MEMORANDUM

RE: Review 2011 Acoustic Tag study design for John Day Dam

Figure 1. Modified from Figure 2 (Anon. 2011). Schematic of the Virtual-Paired Release model for a single dam. Shaded areas of potential handling/tagging effect added by Fish Passage Center.

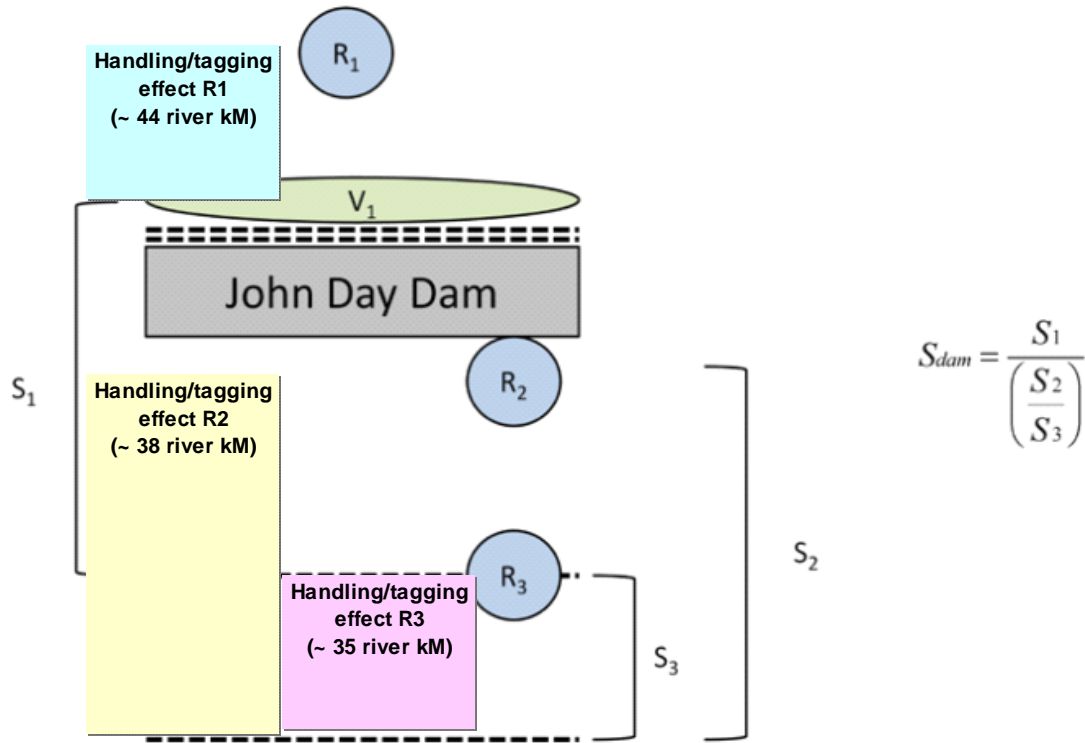
A primary goal of the Lower Columbia River Survival Study for 2011 is to measure the overall survival of fish that pass in several routes of passage through Columbia River dams (Carlson 2010). This approach has several explicit assumptions as outlined in Skalski 2009. Two implicit assumptions not mentioned in model assumptions A1-A10 (Skalski 2009) is that tagging/handling effects are expected to cancel out or be expressed before survival is measured.

These two assumptions are: (i) the handling/tagging effects for release R_1 is expected to be zero by the time these fish are re-counted as virtual release 1 (V_1); (ii) the handling/tagging effects on R_2 and R_3 are expected to be equal and cancel out in the calculation of dam survival (S_{dam}).

The handling/tagging effects on R_2 may be more than those of R_3 for two reasons. First, the approximate river kilometers where handling/tagging effects could be expressed are greater for R_2 than R_3 . The amount of handling/tagging bias, and duration over which it is expressed is unknown. However, since the unadjusted survival of R_2 is measured over a longer reach than for R_3 , this could bias the survival for R_2 low. Second, there is no accounting for any interaction between tagging/handling effect and where the release takes place. One working hypothesis could be that handling/tagging effects have a more negative effect on the subsequent survival in an area that ostensibly contains high predator numbers (e.g. tailrace of a dam) than for downstream releases. Both of the above potential negative biases of S_2 would cause the measurement of S_{dam} to be biased high. This relationship can be shown with a simplification of the equation shown in Figure 1:

$$\uparrow S_{dam} = \frac{S_1 * S_3}{\downarrow S_2}$$
